STORMWATER MANAGEMENT REPORT
PROPOSED RESIDENTIAL SUBDIVISION
2050 DUNROBIN ROAD
CITY OF OTTAWA

PROJECT #: 200977

Rev 2 - Issued in response to Review Comments

APPENDIX K: RESPONSES TO REVIEW COMMENTS

Multiple sub-drains added under filter

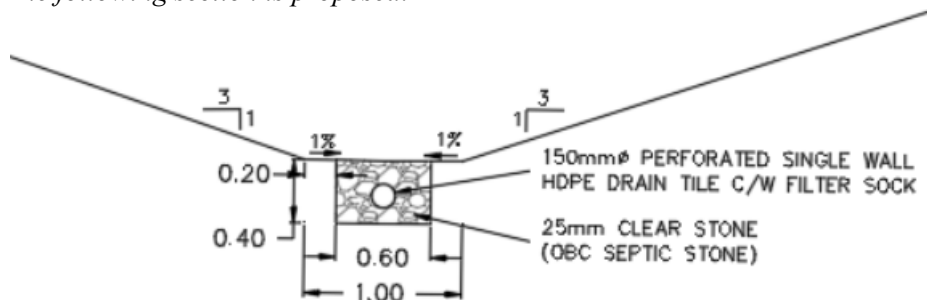
2. If City detail S9 with 250mm perforated subdrain cannot be accommodated, please explore other options that are similarly equivalent to the City detail.

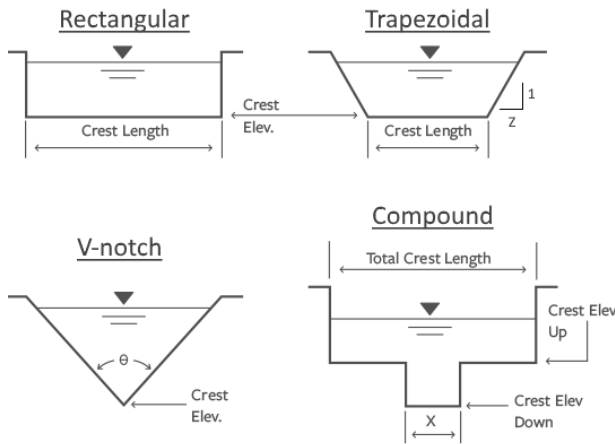
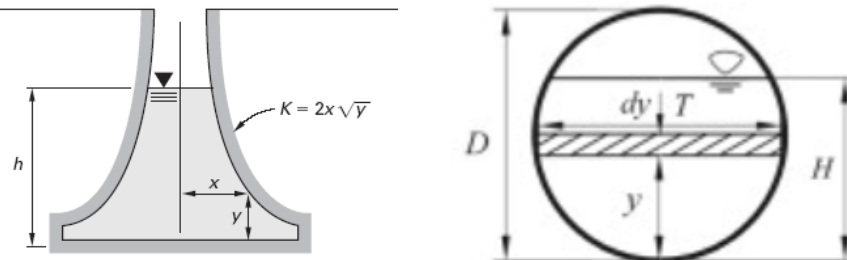
13. Section 7.1.3 provides an equation that defines the discharge rate through the orifices. Please show that the equation, found on page 33 (pdf sheet 38) fulfills the criteria of use. It is not clear how this formula applies in this case.

Reference to the equation has been provided.

The following explanation has not been added to the report as it providing information that should be common knowledge.

It is acknowledged that the equation used is not completely accurate having a maximum error of up to 2.4 percent between the value derived using the provided equation and the values obtained when using separate equations to calculate orifice flow and weir flow. The peak discharge during the 100 year storm event is in the order of 70 L/s. A 2.4 percent error would indicate this number could vary from 68.6 to 71.4 L/s. This error is not significant when considering that the post-development runoff during a 100 year storm event is more than 15 L/s less than the pre-development runoff rate.

PROJECT NO:	200977
DATE:	2024/12/10
SCALE:	1:500
DRAWING NO.:	GR-W

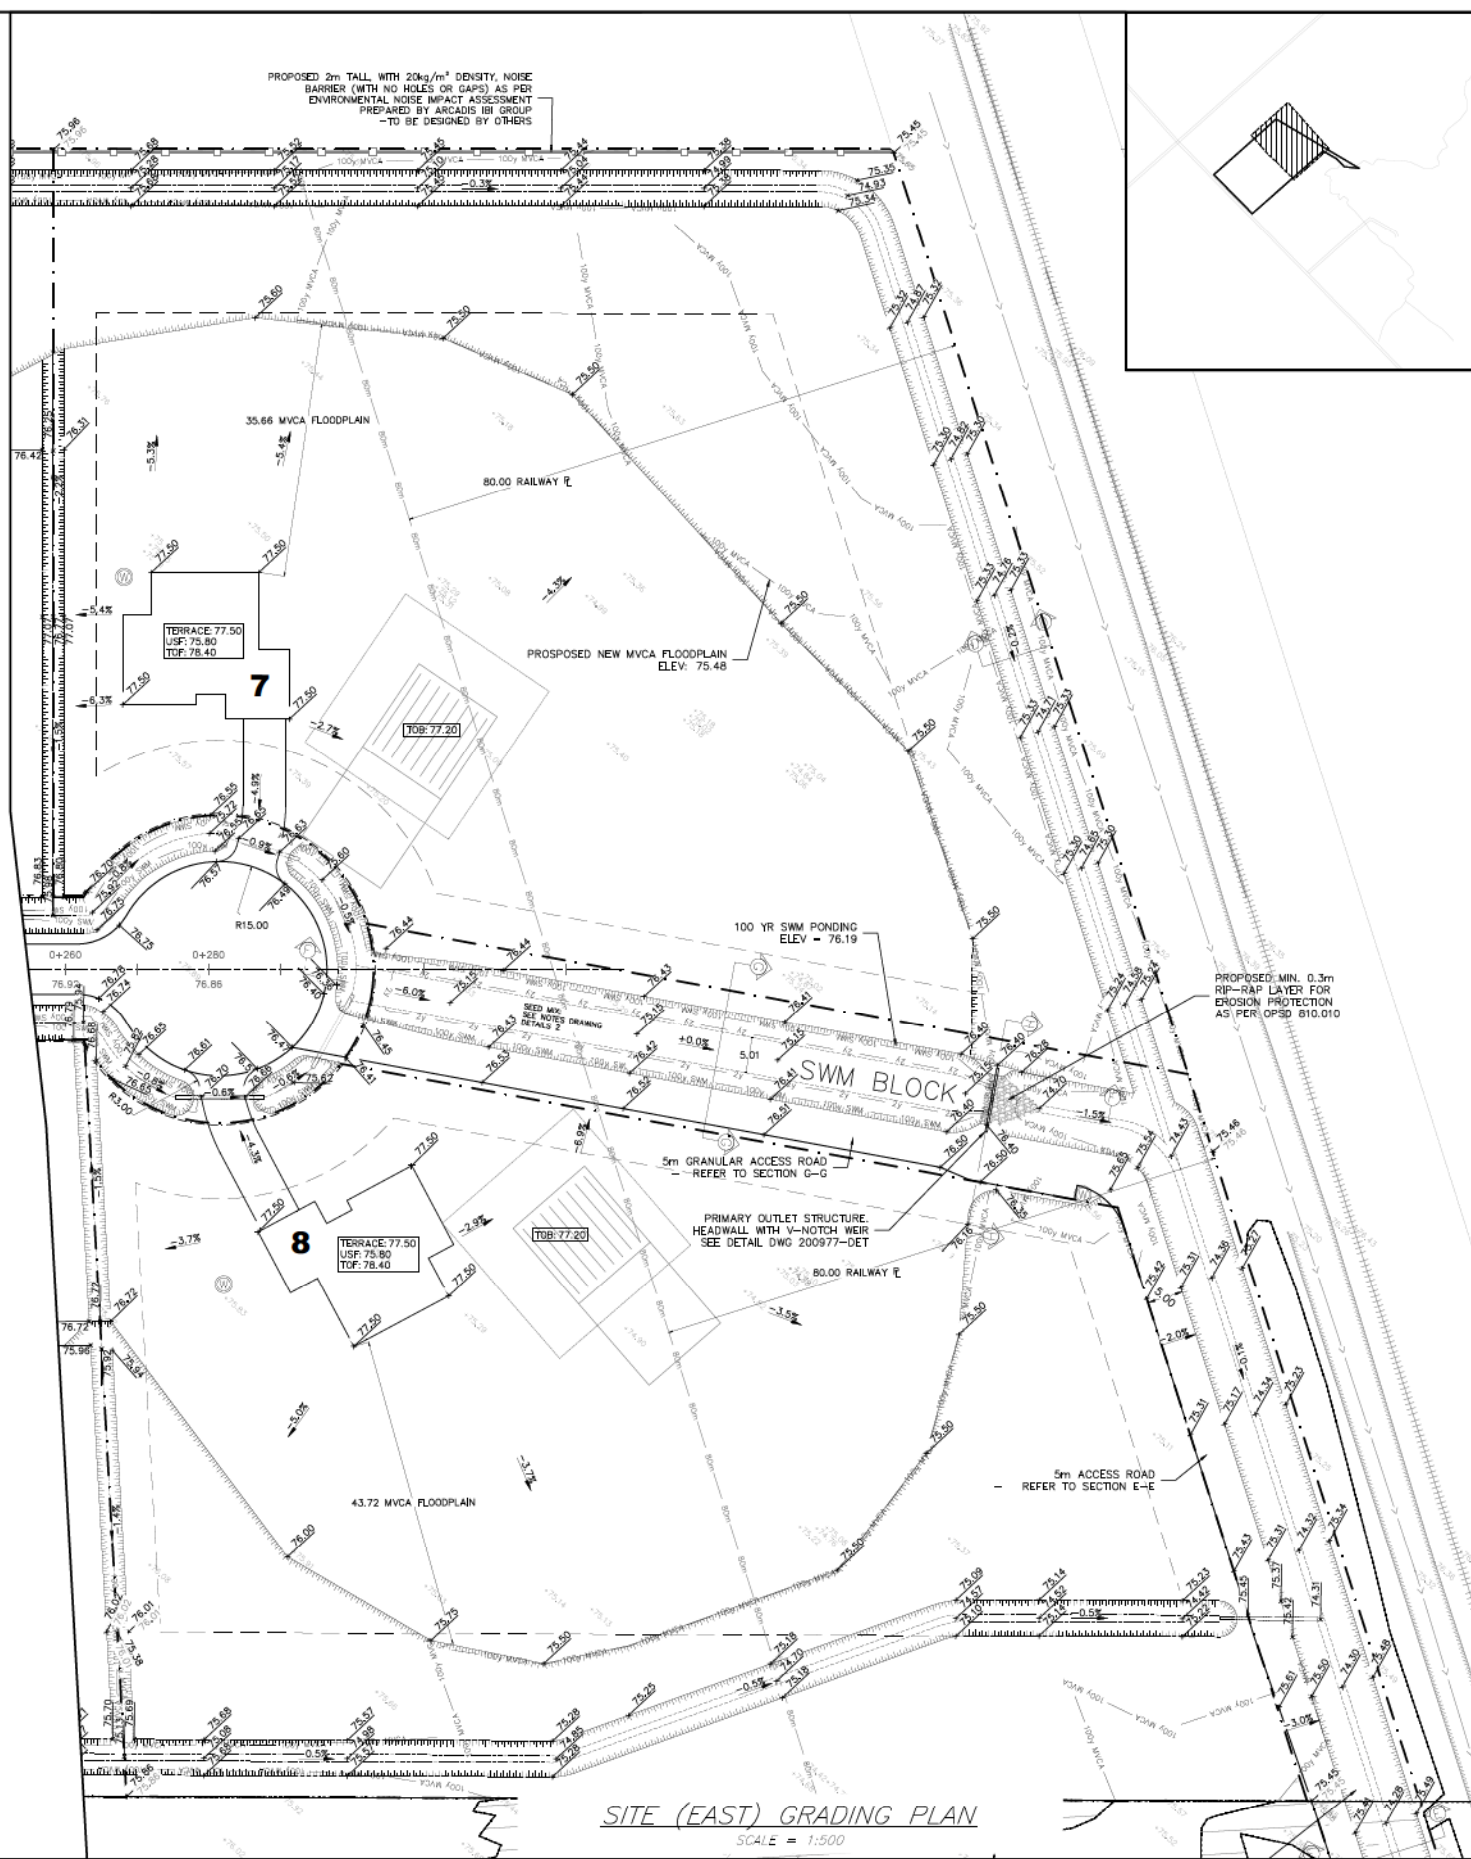
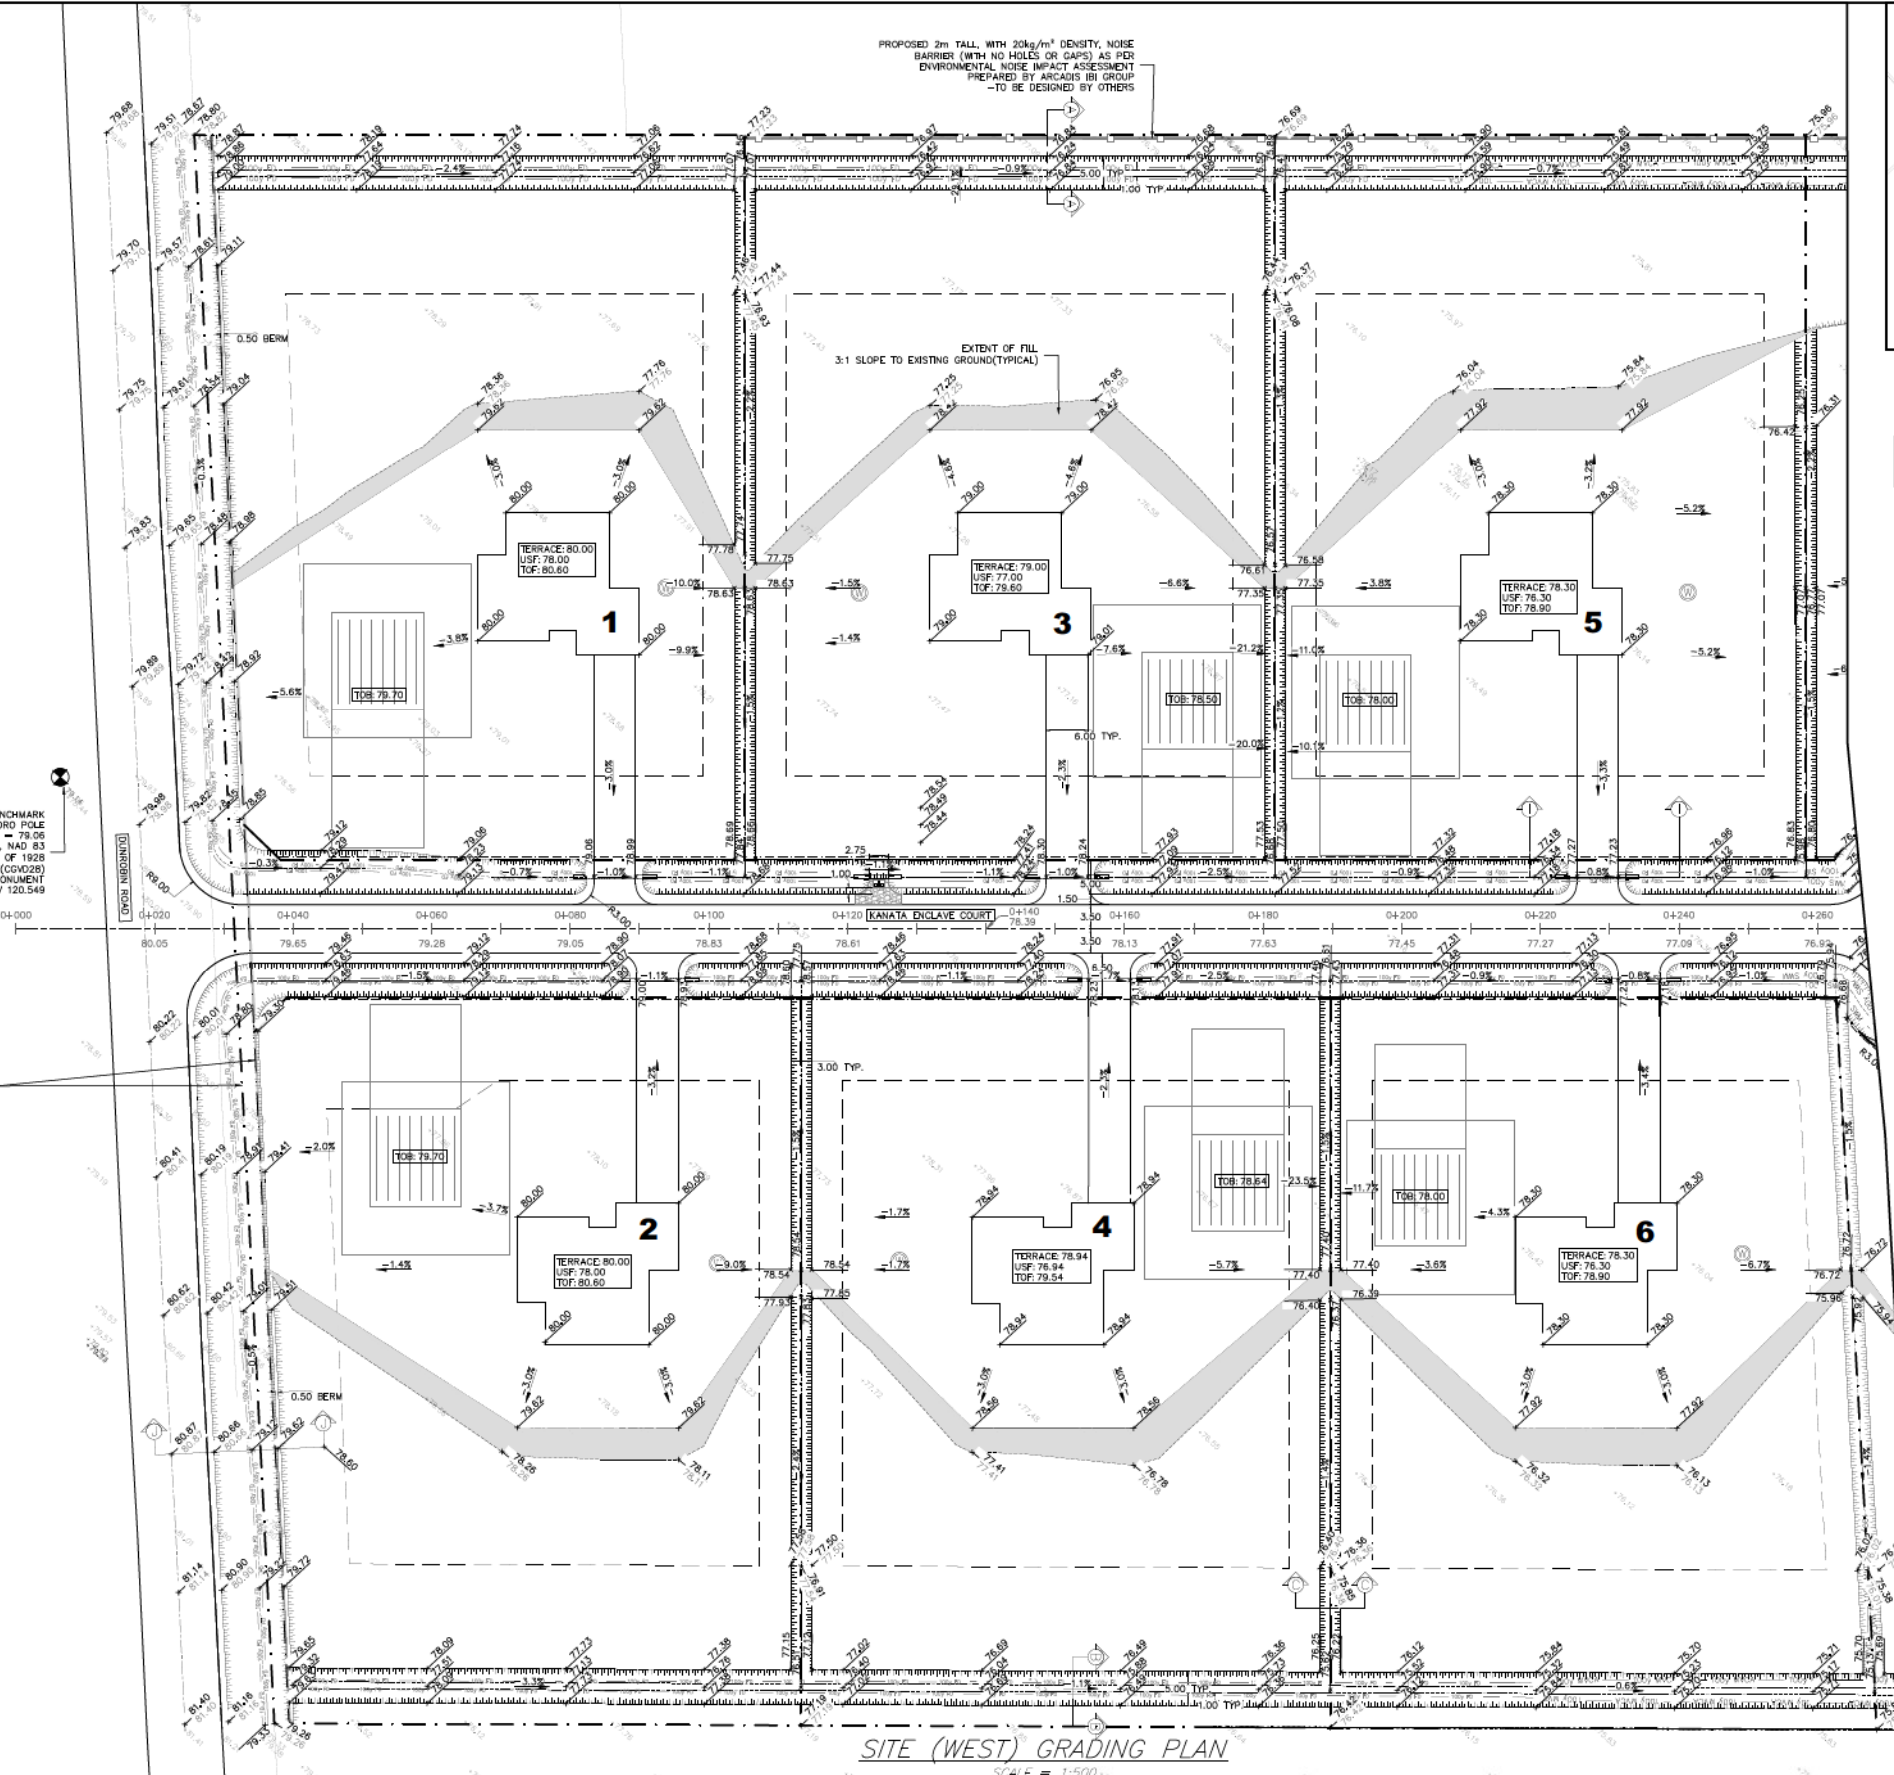
2. Rear yard/side yard swales with slopes lower than 1.5 % needs to be designed as per ditched pipe storm sewer installation, in accordance with the City of Ottawa Drawing S9.
The side yard swales will be sloped at between 1.2 and 2.2 %. The rear yard swales will be sloped such that there is a minimum slope of 0.3 %.

3. All site peripheral swales and roadway ditches with slopes lower than 0.5 % need to be designed as per ditched pipe storm sewer installation, in accordance with the City of Ottawa Drawing S9, with an allowed minimum slope of 0.3%.
The slope of the roadside ditches around the cul-de-sac have been revised to have a minimum slope of 0.5 percent. The slope of the roadside ditch along Dunrobin Road and along the north side of Kanata Enclave Court between Dunrobin Road and station 0+070 remains at 0.3% to accommodate the existing grading of the Dunrobin Road ditch. The Drainage from Dunrobin Road was directed by design across private property with little to no longitudinal slope along the existing roadside ditch. This existing physical condition restricts the grading of the proposed ditch as the proposed ditch is required to accept the runoff from Dunrobin Road. The slope along the swales has been adjusted to have a minimum of 0.3%.

It is not practical to design the first section of the ditch in accordance with the City of Ottawa Drawing S9 as there would be no outlet for the storm pipe.

**TYPICAL ROAD SECTION**  
SCALE = 1:50

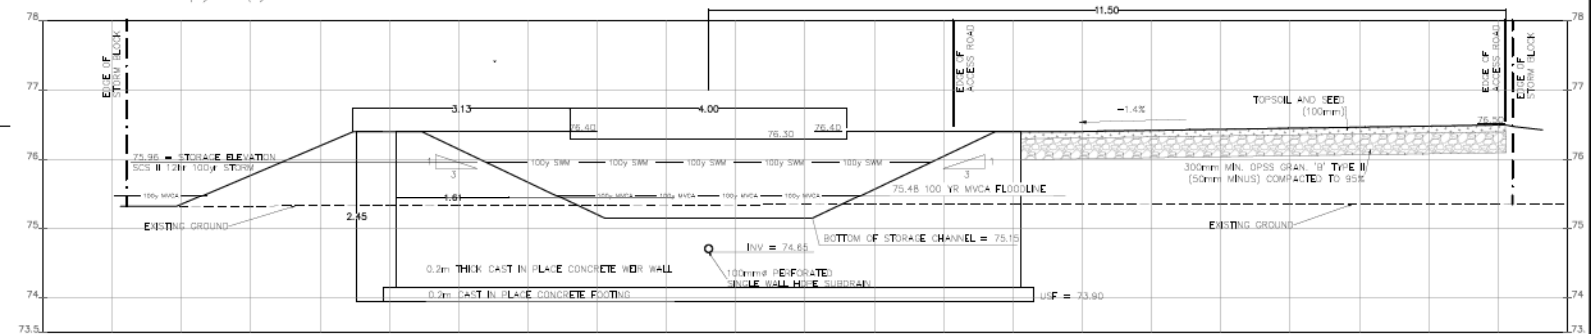
12. Proposed road cross-section detail recommends 300 mm of Granular B, while the City of Ottawa Rural Local Roadway Cross-Section Over Earth, Drawing Number R-27, March 2016, specifies minimum Granular B layer of 400 mm. The Standard also specifies the Performance Graded Asphalt cement. The roadway design needs to be as per City standard Drawing R-27 (Note #1 shall be disregarded) unless the proposed design can be justified as exceeding the City minimum requirements presented on the mentioned drawing.

Road cross section has been revised to be in keeping with Drawing R-27
